June 21, 2019

RE: Third Party Environmental Sustainability Review of Planning Board Filing
Martha's Vineyard Community Services (MVCS) Site Plan Review

Figure 2: Add raingarden/bio (in blue) to manage runoff from main parking lot

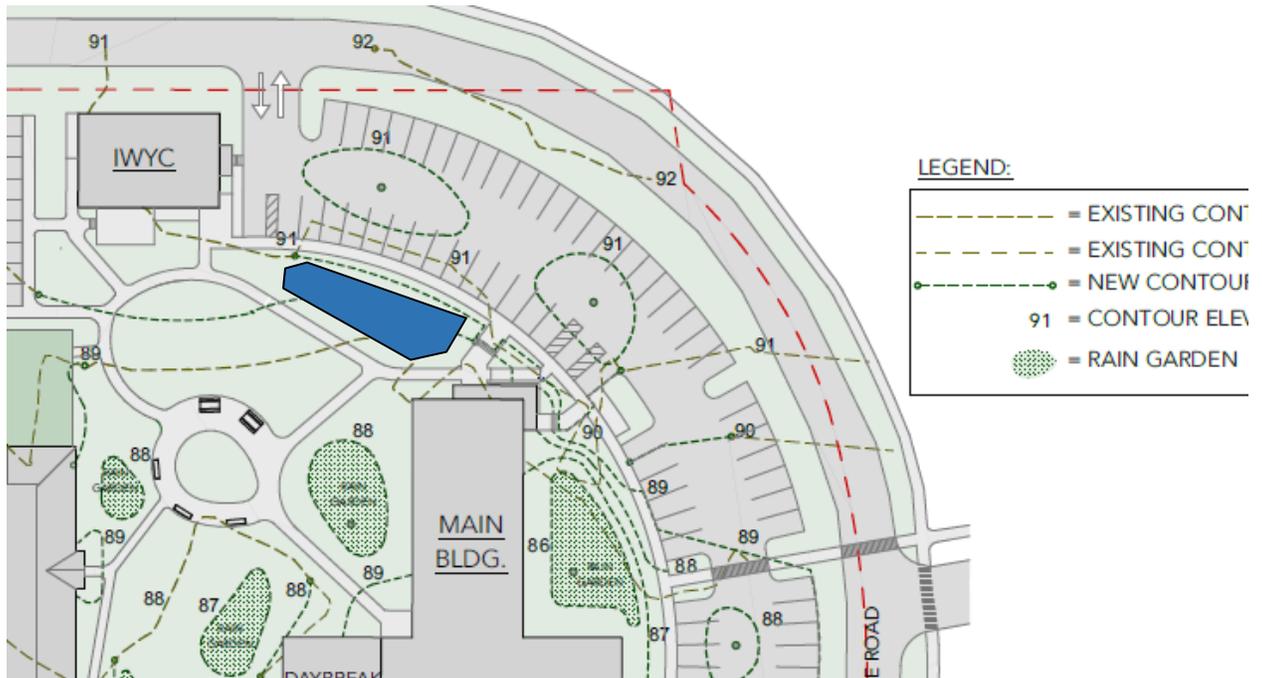
- a. To ensure that BMPs are designed to minimize maintenance and ensure long term performance, the applicant should design raingardens/bioretention to include pretreatment/sediment forebays. The drywells proposed in the center of the parking lot do not offer a pretreatment alternative and are subject to clogging, which could lead to ponding after heavy rains; they also lack treatment for nitrogen reduction. We suggest that the Applicant provide an alternative to the central dry wells (i.e., use porous asphalt or drain to perimeter bioswale/raingarden). Given the amount of potential runoff from the upper section of the main parking, an additional rain garden may need to be added (see Figure 2).
